Subject: Clarifications to Site Investigation Work Plan – PFAS Contamination
Arkema Coating Resins/Cook Composites & Polymers/Freeman Chemical
340 Railroad Street, Saukville, Wisconsin
BRRTS #: 02-46-000767, FID #: 246004330

In response to the questions and comments provided via email on April 30, 2020, we are providing these clarifications to the PFAS Site Investigation Work Plan prepared for the above-described site. The questions/comments presented in the email are listed below with our response immediately following each bullet point.

FIGURE 1 – GLACIAL DRIFT WATER TABLE MAP

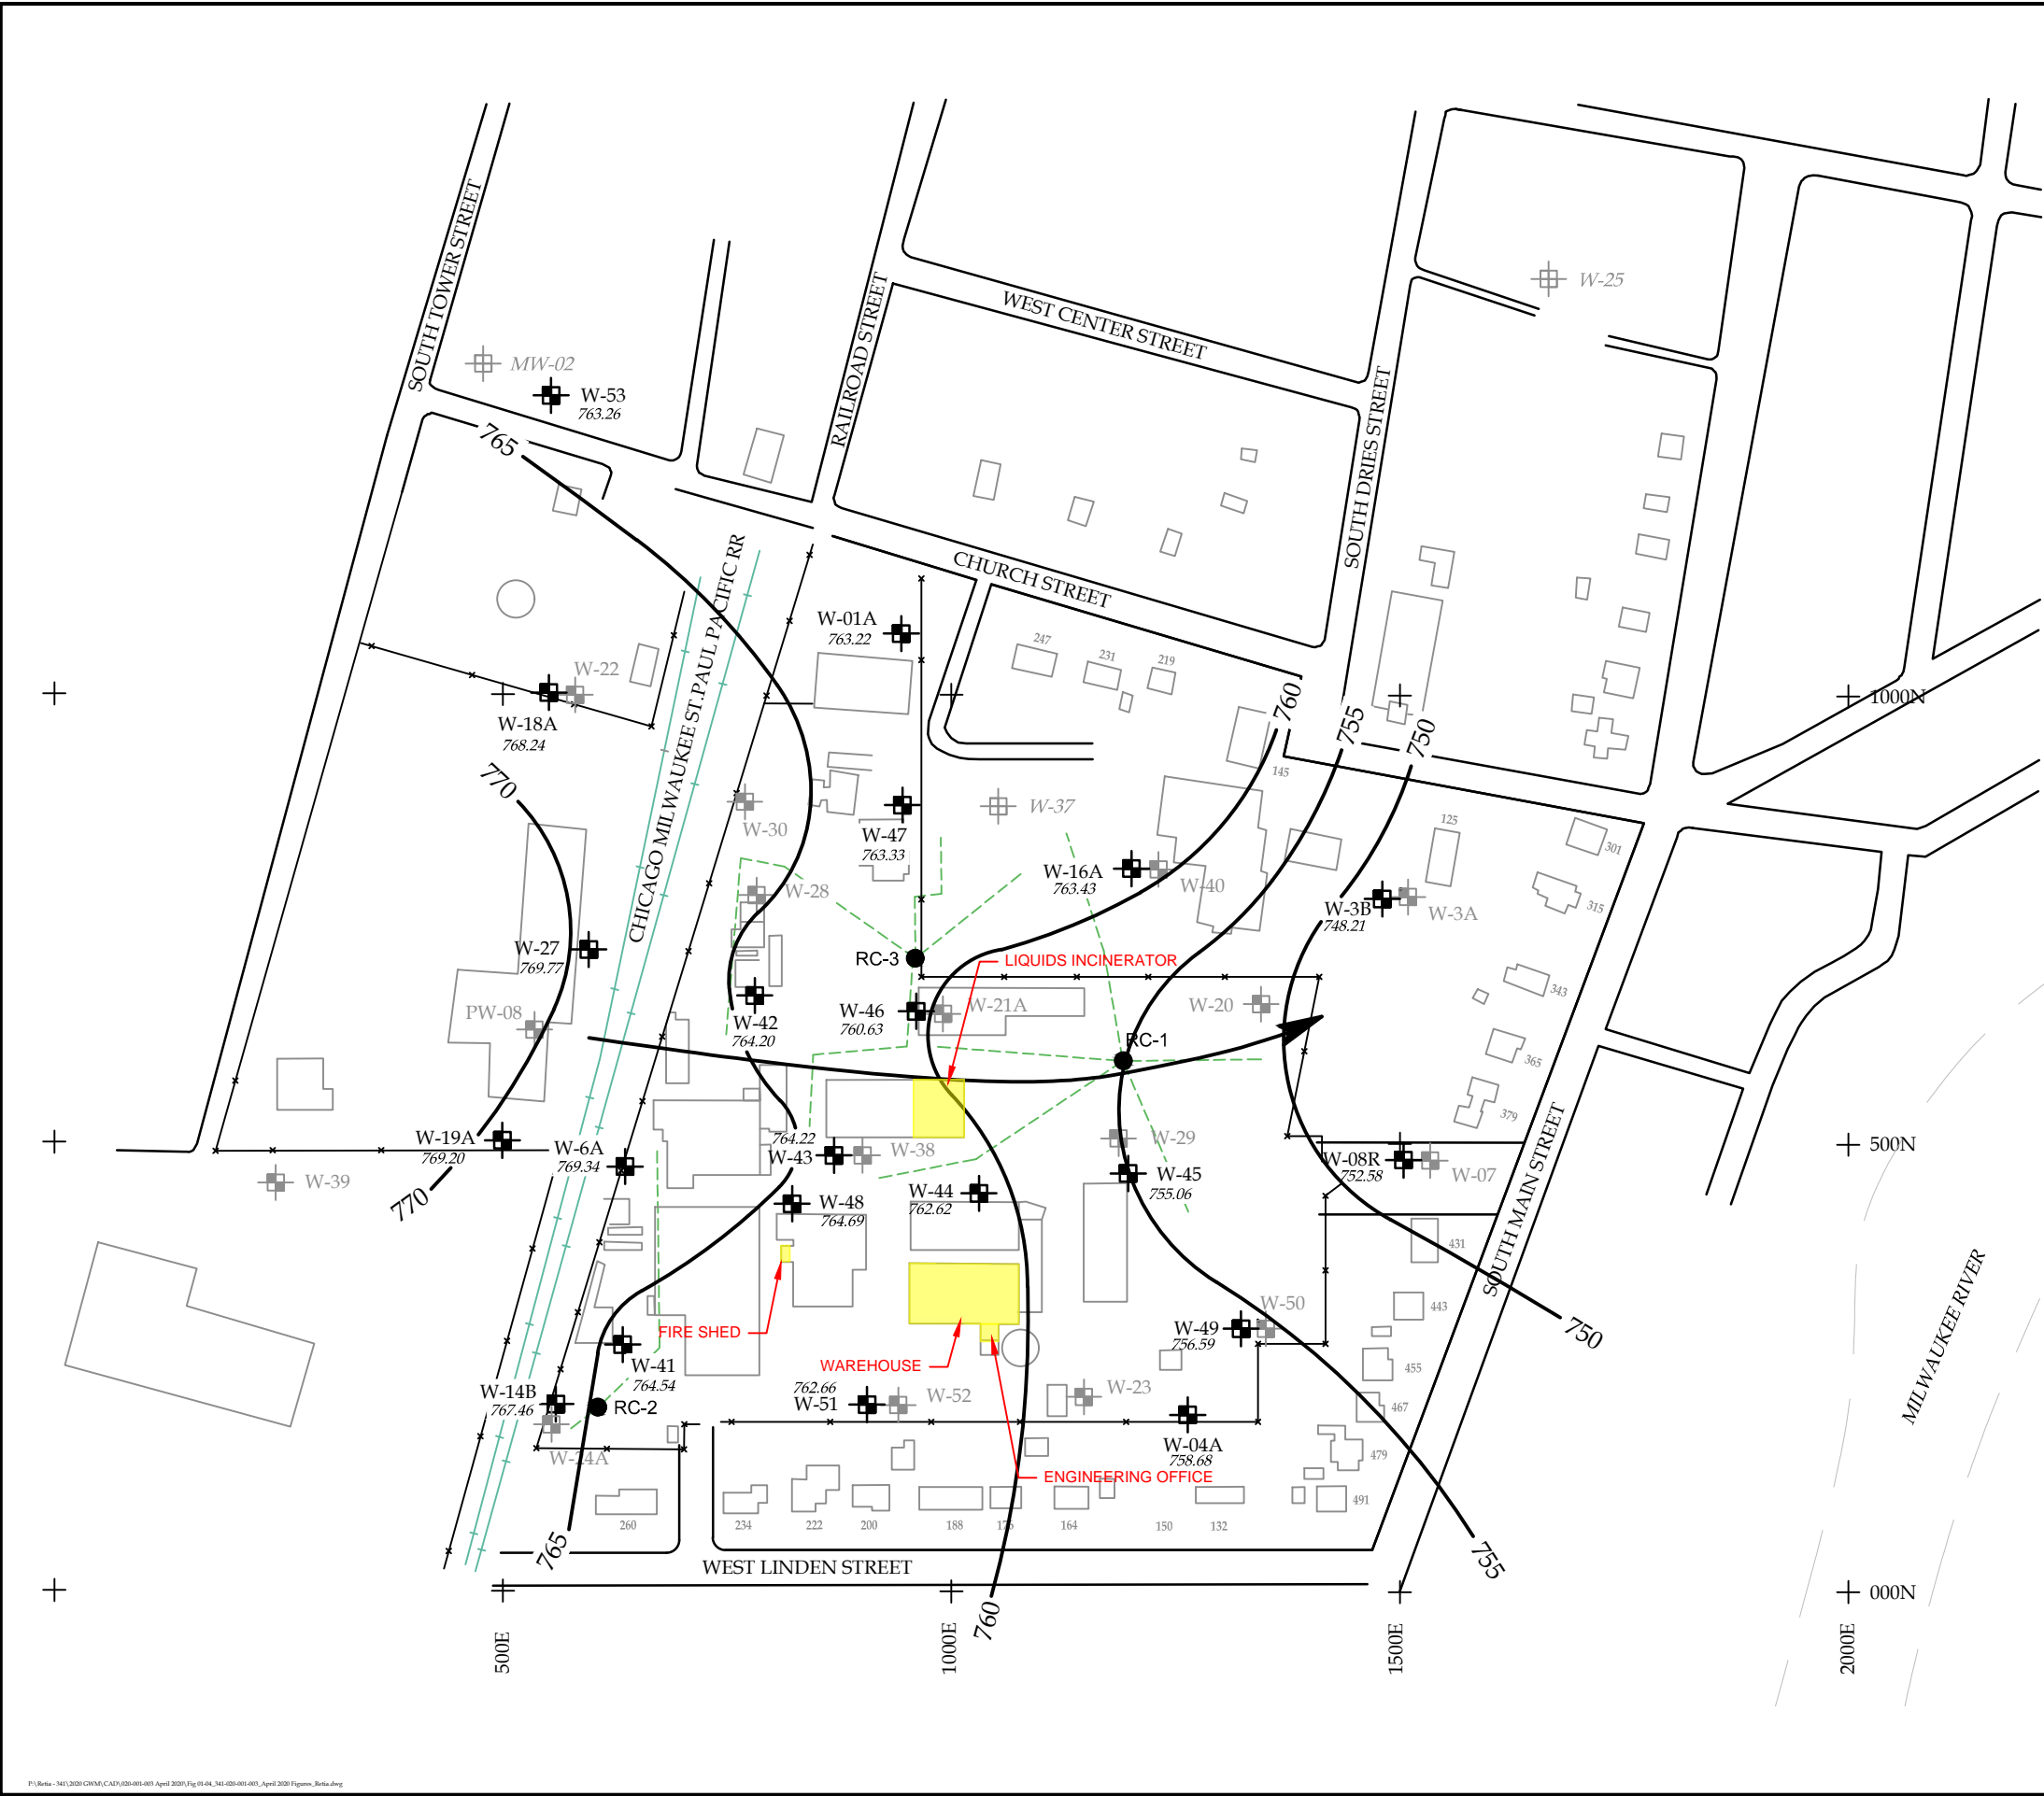
- *Can you put the location where the fire department stored their firefighting foam on the map? We thought it would be appropriate to add sampling from that location.*

- *We thought it would be appropriate to add groundwater samples from wells on the north and east side of the PFAS foam storage and use areas (areas in yellow on Figure 4 of the SIWP) to investigate any potential releases to groundwater from those areas. Can you add groundwater flow directions to your proposed well sampling map?*

According to former employees of the Site, the Village of Saukville Fire Department did not store any firefighting foam at the Site. When the AR-AFFF maintained at the Site in the event of a fire reached their expiration date, the AR-AFFF stored in the AST, drums and the firefighting cart were exchanged for new product and the expired product was donated to the Fire Department for their use. However, upon donation, the Fire Department removed the donated AR-AFFF from the Site. The only known storage locations for the AR-AFFF products on the site are shown in yellow highlight on Figure 1.

See **Figure 1** (attached) for the glacial drift aquifer groundwater flow map based on depth to water measurements made during the April 2020 groundwater sampling event. While there are some minor variations in the flow paths induced by active pumping of several glacial drift extraction wells along the southern portion of the west fence line and gravity drainage and active pumping of water within the glacial drift aquifer by the three (3) Ranney Collectors (RC-1, RC-2 and RC-3 and their associated trench drains depicted with the green dotted lines), overall shallow groundwater flow across the Site is from the west to the east.

Existing glacial drift aquifer monitoring wells W-44, W-46 and W-48 are located to the north of the Warehouse, Liquids Incinerator and Fire Shed, respectively. These monitoring wells are not actively sampled as part of the current groundwater monitoring plan; however, depth to groundwater measurements are collected in each of these wells semi-annually. During the April 2020 groundwater monitoring event, the depth to water in these wells ranged between approximately 5.5 to 8.5 ft bgs. Based on the general west to east groundwater flow pattern across the Site, glacial drift aquifer monitoring well W-08R is located in a general downgradient sentinel well position for the areas of AR-AFFF use. Therefore, in response to DNR's request we propose a sample be collected from W-08 to evaluate the downgradient migration of potential PFAS contaminant constituents in the glacial drift aquifer.

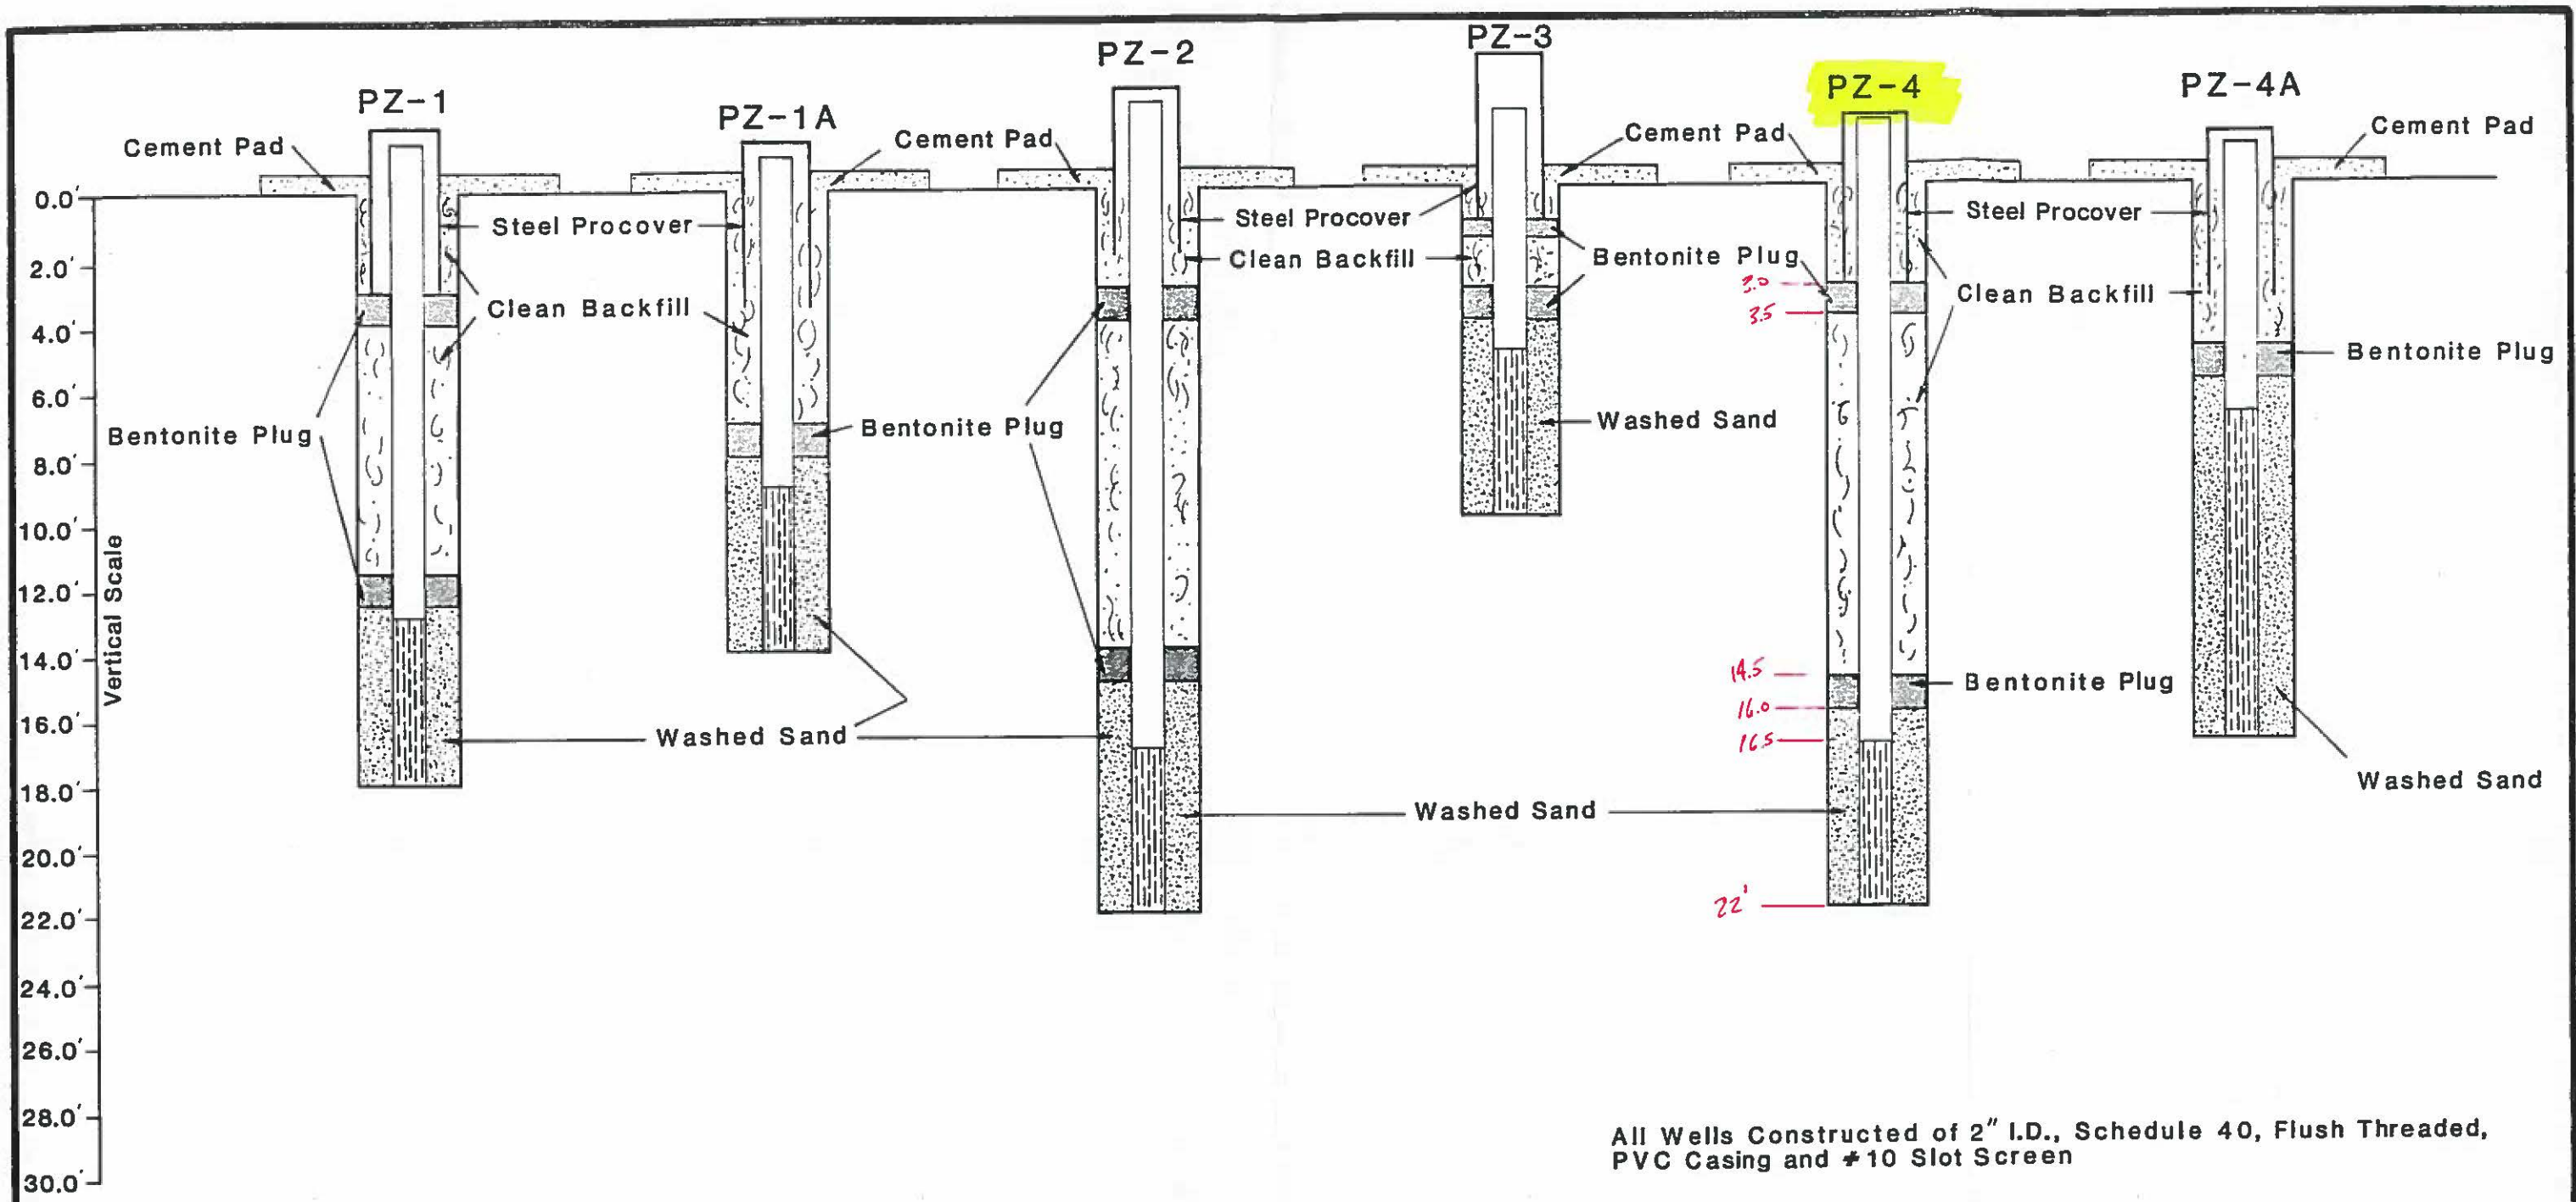
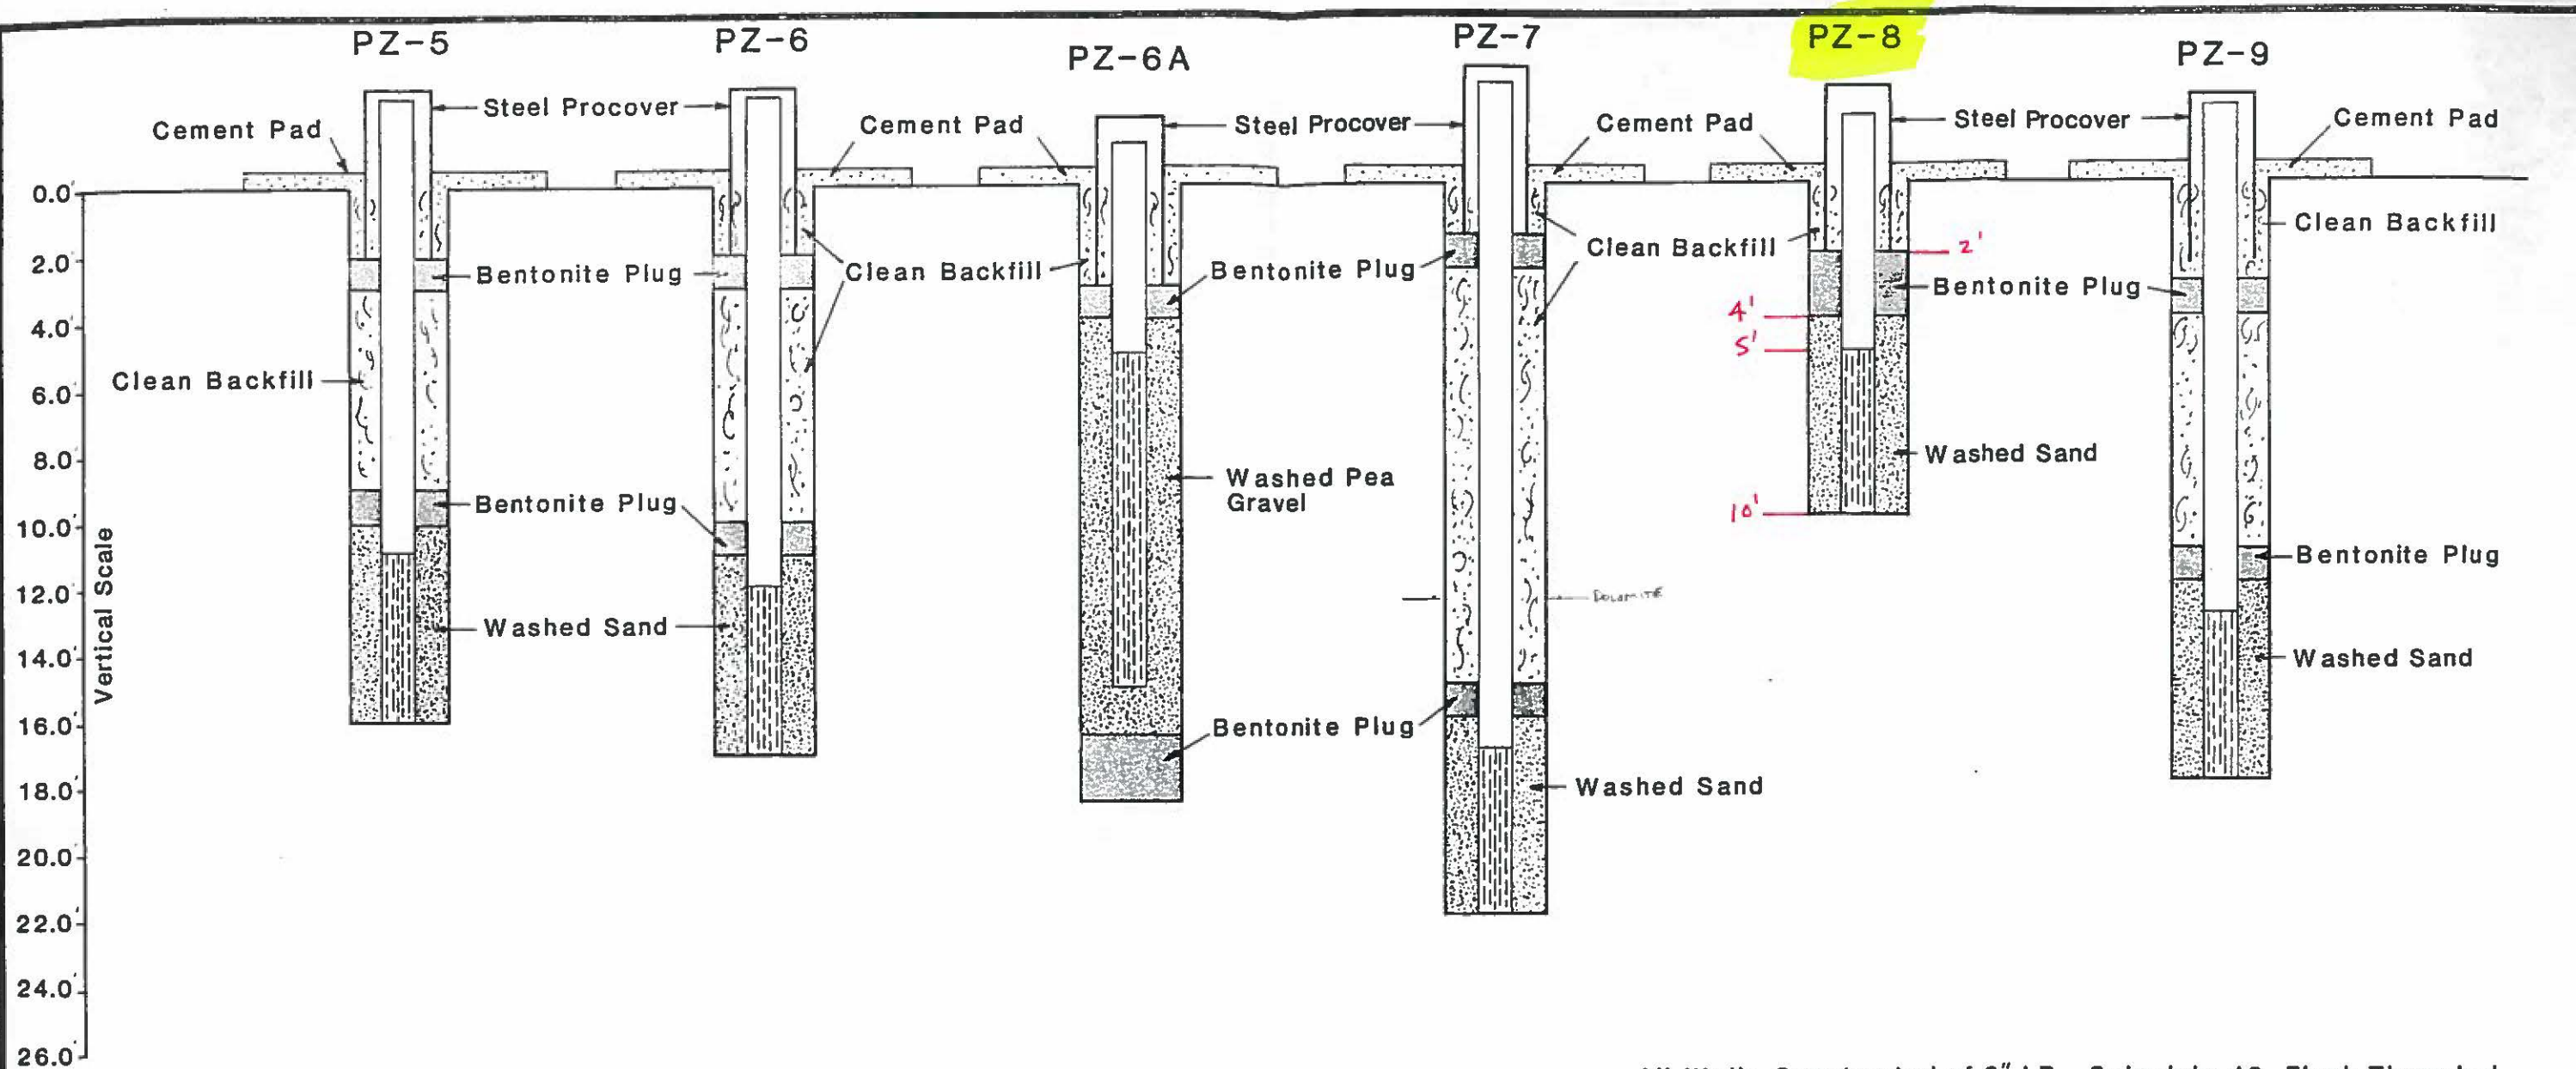
- *Submit well construction details for the wells that are proposed to be sampled.*

Soil boring logs and well construction details for wells W-04, W-08, W-23, W-44, W-46, W-48, W-49 and W-50 are included in **Appendix A**. Please note, W-04, W-08, W-23, W-44, W-46 and W-48 were installed in the early 1980's and the information presented in Appendix A is the extent of the information available regarding these wells. The available information requested regarding soil profiles and well construction details are provided on the attachments.
